FIELD SERVICE BULLETIN # 009

Problem: The need for additional cooling during operation.

Solution: Use high-pressure fans. (Order Fan Upgrade Kit ñ P/N 600-104733)

Fig 1

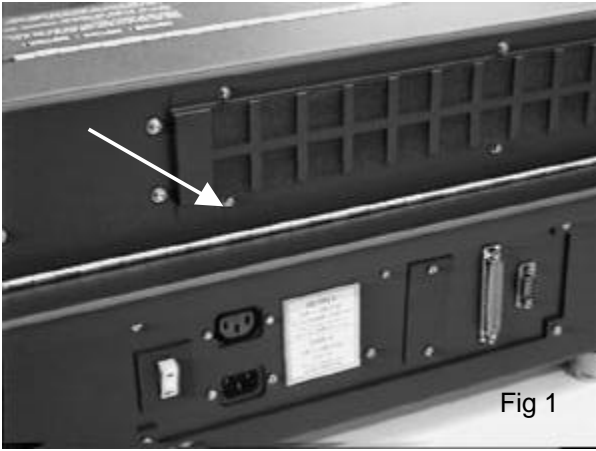
- ∑ Remove the rear filter cover. (Fig 1)
- ∑ Open the upper chassis and remove the air guide. (Fig 2)
- ∑ Remove the hardware that secures the fan chassis. Hardware is under rear filter and can be seen after the rear filter cover/filter are removed.
- ∑ Disconnect fan cables. (Fig 3)

Fig 3

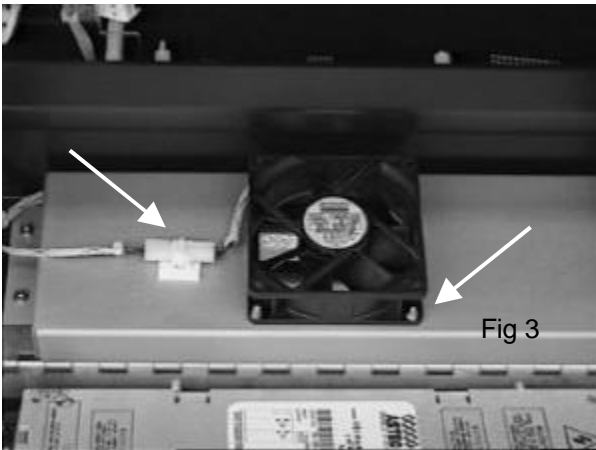
**IMPORTANT: Note direction of arrows on the fans. (Airflow)
Airflow is from the rear to front of imagesetter.**

- ∑ Remove the hardware that secures the old fans to the fan chassis. (Fig 3)
- ∑ Assemble the new fans to the fan chassis.
- ∑ Connect the fan cables.
- ∑ Assemble the filter/filter cover and the air guide back onto the unit.
